# Access Compliance Report

## Public Rights-of-Way

### (Curb Ramps)

Intersection ID: 50665	Main Street: SAMUEL_NEEL_RD	Cross Street: COVE_POINT_DR	Location: SW
ADA ID: D92F9329468A	Ramp Type: Perp	Initial Pass/Fail: Fail	Overall Compliance: No
		Severity Score: 25

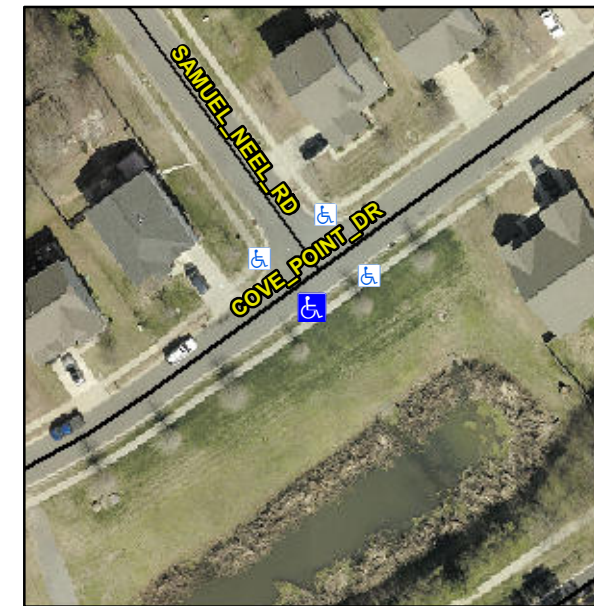
**R304.2.2**

Compliance	Description	Data	Compliance	Description	Data
N/A	Ramp Length (in)	47.0	No	Ramp Slope (%)	14.5
Yes	Ramp Width (in)	48.0	Yes	Ramp XSlope (%)	1.6
N/A	Flare Type LT	N/A	N/A	Flare Type RT	N/A
N/A	Flare Slope LT (%)	N/A	N/A	Flare Slope RT (%)	N/A
N/A	Flare Traversable LT?	N/A	N/A	Flare Traversable RT?	N/A
N/A	Landing Length (in)	N/A	N/A	DWS Provided?	N/A
N/A	Landing Width (in)	N/A	N/A	DWS Contrast?	N/A
N/A	Landing Slope (%)	N/A	N/A	DWS Length (in)	N/A
N/A	Landing X Slope (%)	N/A	N/A	DWS Full Width?	N/A
N/A	Landing Curb? (Y/N)	N/A	N/A	DWS Offset (in)	N/A
N/A	Shared Landing?	N/A			
N/A	Gutter Ponding?	N/A	N/A	Gutter Slope (%)	N/A
N/A	Gutter Lip Ht (in)	N/A	N/A	Gutter X Slope (%)	N/A
N/A	Painted X Walk1?	No	N/A	Painted X Walk2?	N/A
	X Walk 1 Direction	To NW		X Walk 2 Direction	N/A
N/A	X Walk 1 Width (in)	N/A	N/A	X Walk 2 Width (in)	N/A
	X Walk 1 Slope (%)	4.2		X Walk 2 Slope (%)	N/A
	X Walk 1 X Slope (%)	0.9		X Walk 2 X Slope (%)	N/A

**Remove & Replace Entire Ramp.**
